Texas Commission on Environmental Quality Waste Permits Division Correspondence Cover Sheet

Re: Response to Technical Notice of Deficiency (NOD)

Proposed Municipal Solid Waste Permit No: 207C Tracking No. 29656107; RN102143294/CN600756290

Permit Major Amendment Application

> FIGURE IIIH-C-11A

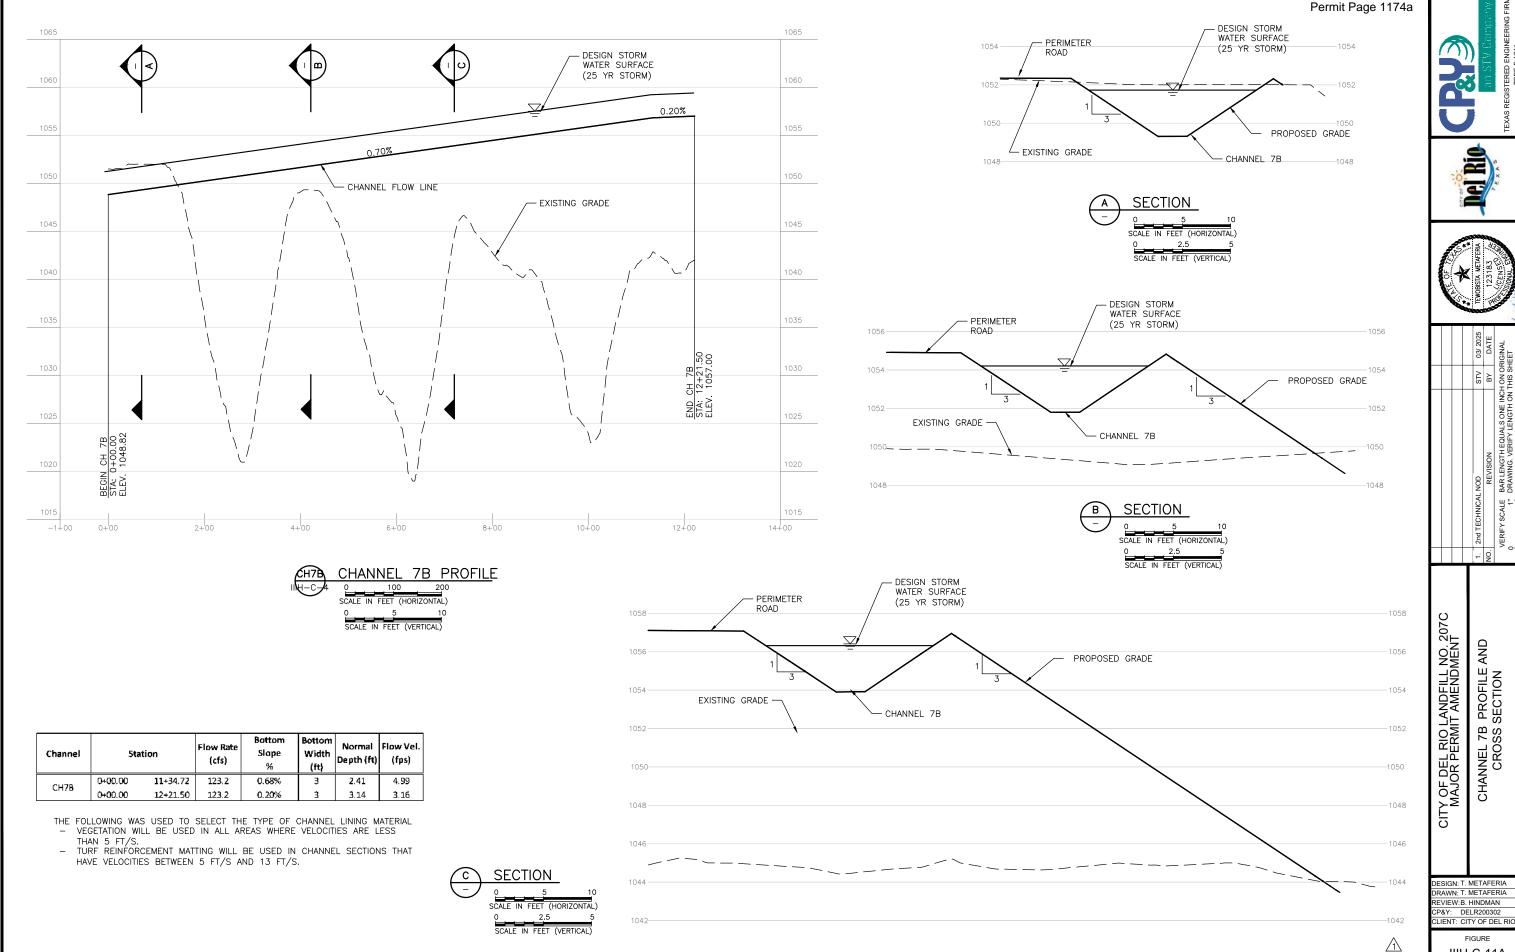
T16	305	Part III	330.63(c)(1)(B)	Appendix IIIH	Incomplete	Comment: The response to Comment T40 of the first NOD states, "The cross sections for Channel 1, 6, 7 and 8 will be provided with the second round of TCEQ comments." Provide the requested information. Response: Cross Sections have been included in this submittal under Appendix IIIH-C.
